Title	REACTOR BUILDING DELAMINATION REPAIR- PHASE 3 CONCRETE REMOVAL
RE	Aaron Mallner

A.5 Solution Statement

- 3) **Concrete Removal (EC 75219)** – This EC will address the removal of the existing delaminated concrete. Method will include a combination of hydro demolition as well as mechanical removal/saw cutting methods. Contract vendor SGT will be providing the implementation of the removal. This EC shall also review the depth of removal, rebar removal requirements, and necessary work platforms associated to perform the work. Consideration shall be given to any stabilization required to support the delaminated concrete during removal activities.

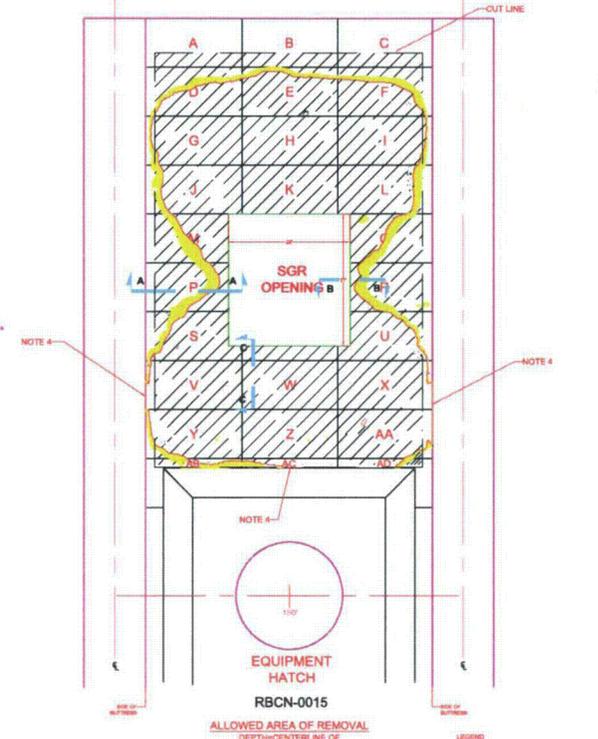
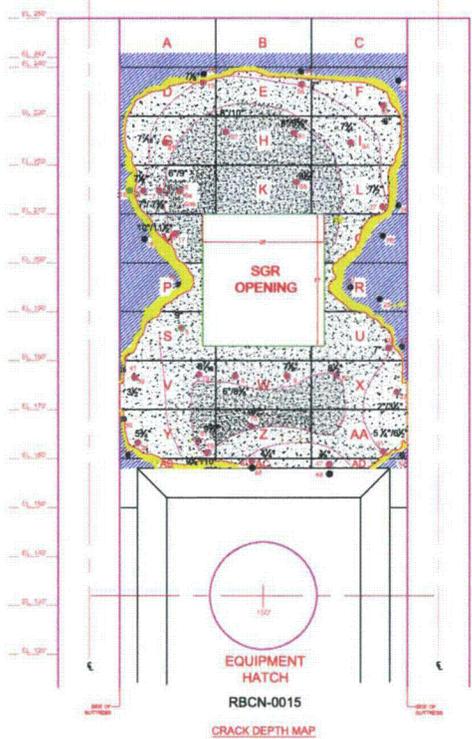
Discipline/Program Review		Scope of Review	
System Engineering		EC 75219 Final Review	
Reviewer	Discipline	Date	Turnover Required?
Scot Stewart	Penetration Sys Engineer	1/29/10	No
Item	Comment	Resolution	
1	Drawing SK-75219-C001 – Typo in Note 3, “AMY” should be “MAY” Typos in Note 4, 1. Hydrodemolitiondamage should be Hydrodemolition damage. 2. Responsiblecivil should be responsible civil 3. “edces” should be “edges” 4. “descetion” should be “discretion”	Drawing SK-75219-C001 has been revised, please see latest revision.

<p>depth. Drawing notes centerline of hoop tendon. Drawing needs to specify removal area from specific reference points so that cut lines can be laid out by SGT Field Engineers. Recommend extraneous information be deleted from drawing for clarity. Should provide contour requirements at top to allow concrete pour. This may also apply to containment opening. Reference dimensions need to be specified. (Larry Davis 704-618-2568)</p>	
9	<p>Sketch G01R0 SK-75219-C001 << Typos in Notes 2, 3, and 4 >></p>	<p>Please see revised Sketch in Section G01.</p>
10	<p>Note: Testing requirements throughout EC are beyond the typical requirements that SGT performs regularly. Extra time will be needed for planning, mock-up, implementation, etc.</p>	<p>Any necessary mock-ups may be completed at the discretion of SGT</p>
11	<p>ASTM D 4580 is not applicable to this project. The sounding equipment and grid layout cannot be achieved through rebar for obvious reasons. (Paul Gosselin xt 1824)</p>	<p>Procedure B of ASTM 4580 is quite applicable. The intent is to use the instructions contained in the standard as <u>a guide</u> for using a hammer to sound concrete after the major delamination is removed. This will ensure no secondary pockets of delamination remain in the wall before concrete replacement.</p>

Item	Comment	Resolution	
General comment on SK 75219-C001			
1	Line weight in color do not print as a hard solid line	Drawing SK-75219-C001 has been revised, please see latest revision.	
2	Why is the first elevation call Fig. 3 when the second elevation has no Fig. identification?	Drawing SK-75219-C001 has been revised, please see latest revision.	
3	No ledged for concrete removal limits	Drawing SK-75219-C001 has been revised, please see latest revision.	
4	Hatch pattern comes all the way to the buttress; it should stop 6" before buttress.	Drawing SK-75219-C001 has been revised, please see latest revision.	
5	Extraneous delamination information should be removed from the second elevation view and the hatch pattern should cove the entire area (less dense pattern).	Drawing SK-75219-C001 has been revised, please see latest revision.	
6	The "construction opening section should be called B-B and shown on the elevation view; also a 90 degree cut should show a similar detail.	Drawing SK-75219-C001 has been revised, please see latest revision.

7	The 8" plus or minus 1" is not generous enough, the book says 7" min for # 8, I would say 9" min and add a note to say that	Drawing SK-75219-C001 has been revised, please see latest revision.

splice must be planned around obstructions such as horizontal tendon ducts, length will vary. Also it is my understanding that near the "dog house" the #8 @12" transition to #11 @ 9". Therefore, # 11 will require more than the minimum 7".	
8	Section A-A should not say 10" max removal, it should say 10" typical, see note 3	Drawing SK-75219-C001 has been revised, please see latest revision.
9	Section A-A please show center line of buttress for clarity and the buttress itself is not drafted in the proper proportion.	Drawing SK-75219-C001 has been revised, please see latest revision.
10	Detail A, I thought 10" deep was to the centerline of hoop tendon, it is not show that way. Also surfaces should be shown rough and delineated "see EC 75220 D.2 "preparation of concrete surface"	Drawing SK-75219-C001 has been revised, please see latest revision.
Section D Comments		
13	In Section D.2 add: <i>13. Conduct survey before detensioning , after detensioning, and establish construction control so that formwork can be properly placed so as to verify required minimal membrane thickness as well as the alignment of reinforcing steel.</i>	If a survey is required prior to and just after detensioning it needs to be included in EC 75218 which implements work around the detensioning schedule. This EC assumes all that work is completed and work is ready to commence on the removal. Please contact Ken McEwan to incorporate this EC comment as needed into EC 75218.

14	<u>Removal of concrete</u> [below is also note 1 on drawing C001] 1. SK-75219-C001 depicts the approximate limits and depths of delaminated concrete, limits of unsound concrete will vary, however, limits of concrete removal are expressly shown. When unsound concrete is discovered beyond the limits of removal the Responsible Engineer shall be contacted prior to its removal. In certain areas/circumstances hydrodemolition shall be discontinued and hand methods of removal shall used with chipping tools less than 60 pounds in weight. [see note 4 on drawing C001] 2. [last part of section], add the word "horizontal" hoop tendon 3. when spalled areas pass beyond the 10" depth, refer to note 1 and	Additional wording was added to step, however, no specific tool weight shall be specified based on the variety of potential circumstances which may arise. ICRI documents recommend no greater than 30 lb equipment to prevent micro-cracking. As such it is left at the discretion of the RE using the Concrete repair manual as a guide. Added Added
